Nature of Work: REMOVE EXIST. ROOFING, INSTALL NEW LIGHT WEIGHT TILE 16 SQ

RE: Re-roof at the Residence at 7682 Abaline St, Sacramento, CA
This inspection and letter is our Job # 02-1022.

RE: Re-roof at the Residence at 7682 Abaline St, Sacramento, CA
This inspection and revised letter is our Job # 02-1022.

SKETCH - ROOF PLAN
 ~SCALE - 1" = 10'

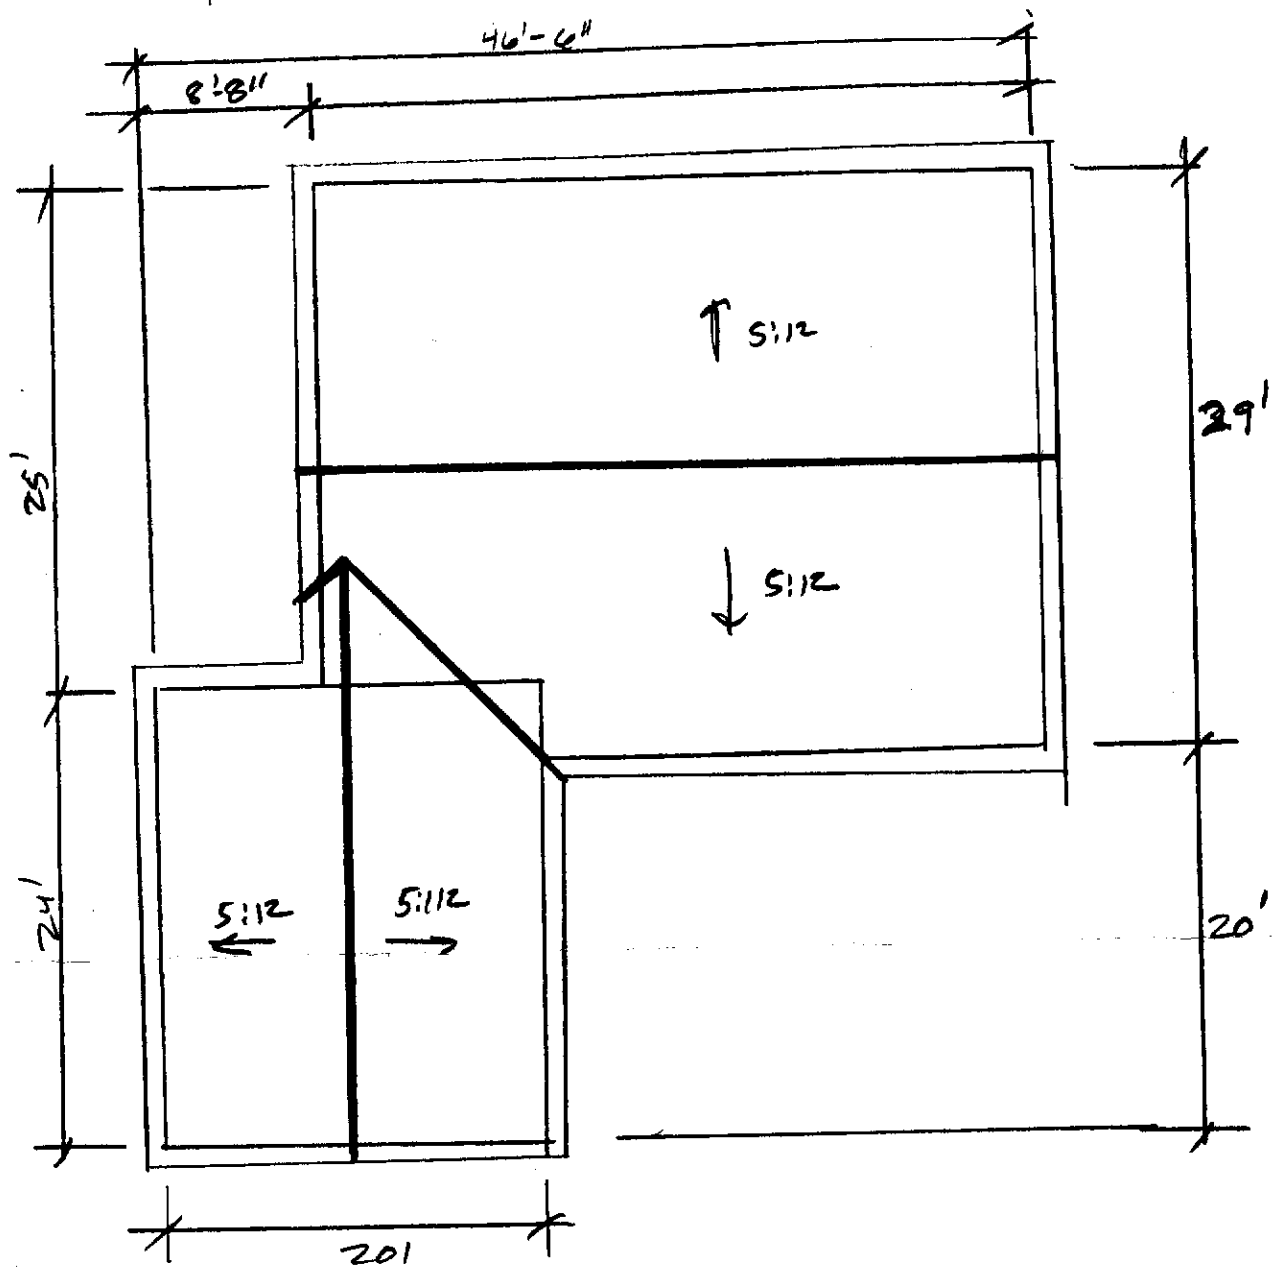
The residence is a 1-story building with the standard living areas and garage. Attachment #1 shows a sketch of the roof plan with approximate dimensions.

Thus, it is my professional opinion that it is acceptable if all layers of the existing roof coverings be removed, plywood (or OSB) is placed or the skip sheathing filled in with 1x material, new 30# felt placed, and then re-roofed with a light weight tile, with an installed weight of 6 psf or less, installing it per the manufactures recommendations.
